NRC TABLETOP EXERCISE HVAC CHILLERS CONTROLS

NRC FEEDBACK ON NEI/EPRI CCF EVALUATION METHODS FOR THE CONTROL ROOM HVAC CHILLER CONTROLS TABLETOP EXERCISE

NEI Presentations 3 & 5: Chiller Controls Examples

Construct a block diagram

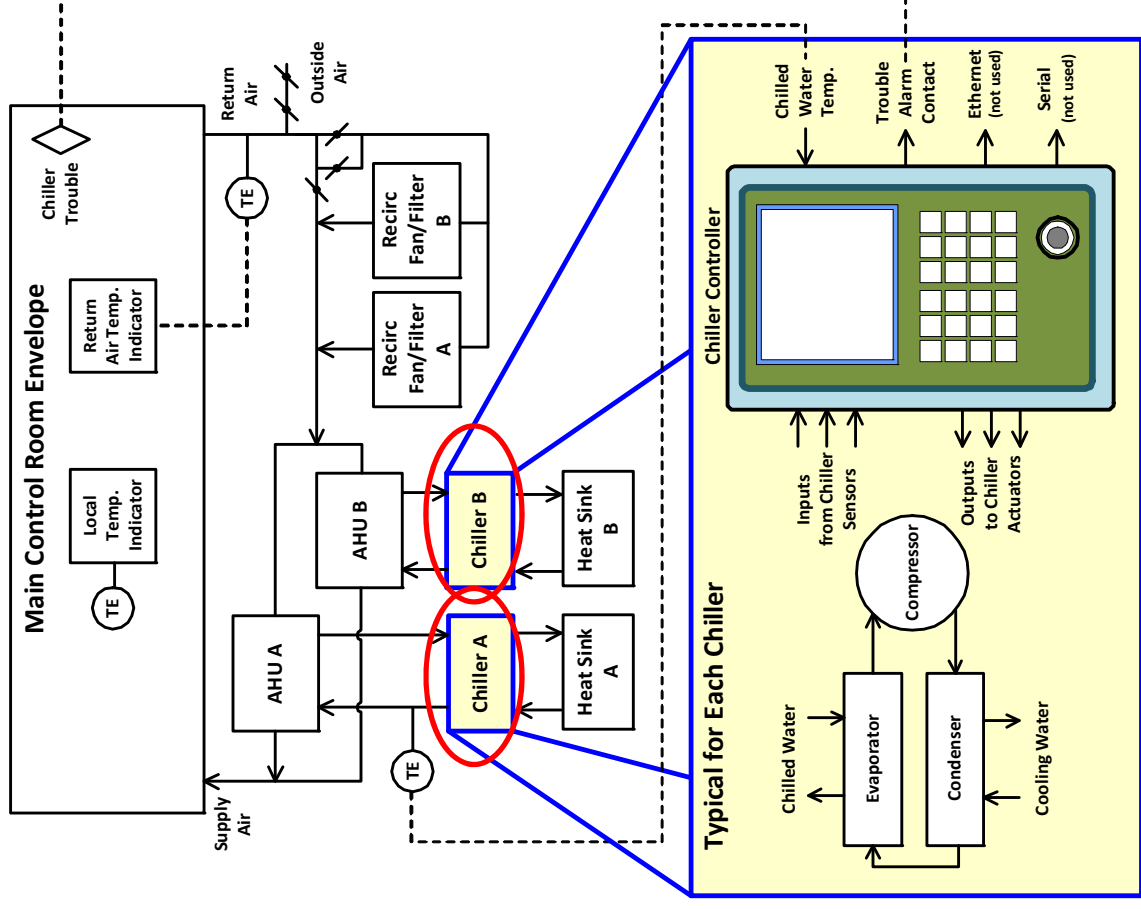
BTP 7-19 Section 4.1
 NUREG/CR-6303,
 Guidelines 1 and 2
